Heavy duty vehicles: GTR No. 5 (WorldWide

harmonized Heavy Duty On-Board Diagnostic systems)

# Proposal for Amendment 1 to Global Technical Regulation No. 5

# Submitted by the experts from the European Commission and the International Organization of Motor Vehicle Manufacturers\*

Figure 4, amend to read:

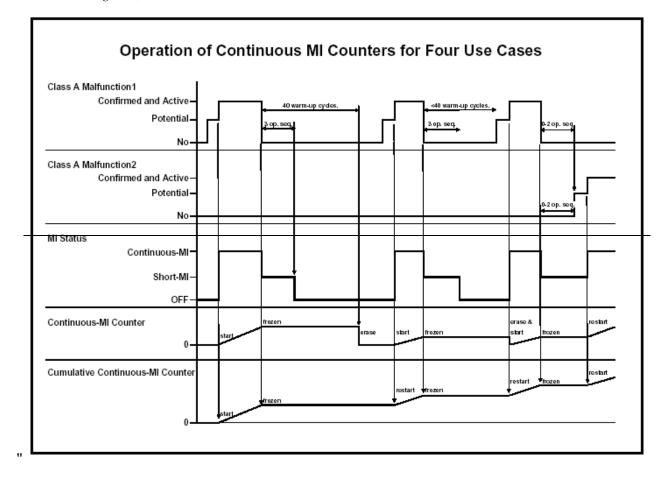
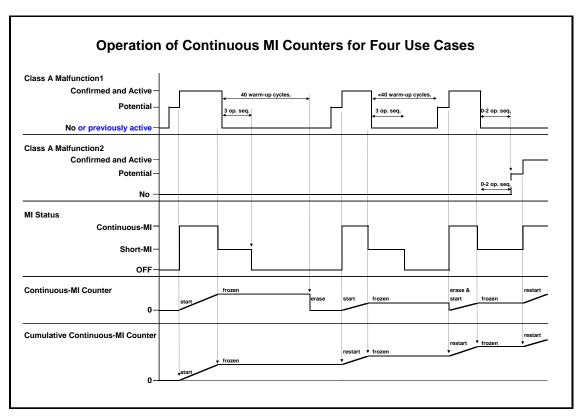
Note: Details related to the deactivation of the continuous MI are illustrated in figure 4bis below in the specific case where a potential state is present.

- 19. Details of this mechanism are illustrated in a new figure 4bis, but figure 4 needs to be modified accordingly.
- 20. This new figure aims at illustrating the continuous MI deactivation scheme in 3 typical cases and at reinforcing the consistency between the figures and paragraph 4.6.3.1.4.

"Figure 4bis: Illustration of the continuous MI deactivation principle

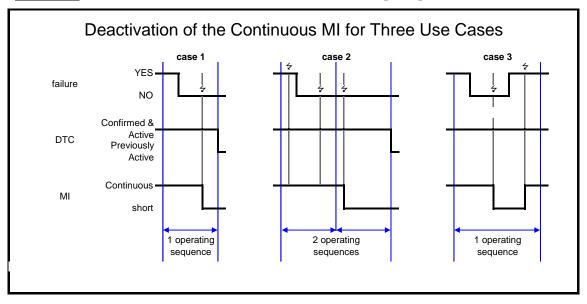
Insert a new figure 4bis, to read:

- 18. The continuous MI is deactivated as soon as the monitor has concluded the absence of the malfunction. On the contrary, the status of the malfunction changes from confirmed and active to previously active at the end of the operating sequence.

- means the point where monitoring of the concerned malfunction occurs.
- M means the operating sequence when the monitor concludes for the first time that a confirmed and active failure is no longer present.
- case 1 means the case where the monitor does not conclude the presence of failure during the operating sequence M.
- case 2 means the case where the monitor has previously concluded, during the operating sequence M, the presence of the malfunction.
- case3 means the case where the monitor concludes, during the operating sequence M, the presence of the malfunction after having first concluded to its absence."
